Date Issued :	March 29, 2024	PCN Number :	514946
Reason for Change :	Packaging Method/Quantity Changing		
Description of Change :	This notification is to inform you about part(s) listed will undergo changes for packaging size/ packaging specification change. No changes will be made to product as part of this change.		
Assessment of Change :	Drop Test		
Planned Implementation Date :	September 30, 2024		
Customer Sample Availability Date:	July 31, 2024		
Last date to request Samples by Customer :	July 31, 2024		
Please note if Samples are not requested as per Customer Samples Request date, it may take additional 4-6 weeks to arrange Samples.

Before Picture

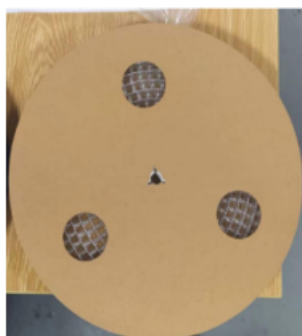
■ Change packing from paper reel to plastic reel

Before change :

外径OD	330mm
宽度Width	24mm
轴心core OD	100mm

After change :

外径OD	330mm
宽度Width	24.4mm
轴心core OD	100mm

- To prevent the generation of paper scraps, we plan change packing from paper reel to plastic reel

- Product Impact: No impact to fit, form or function
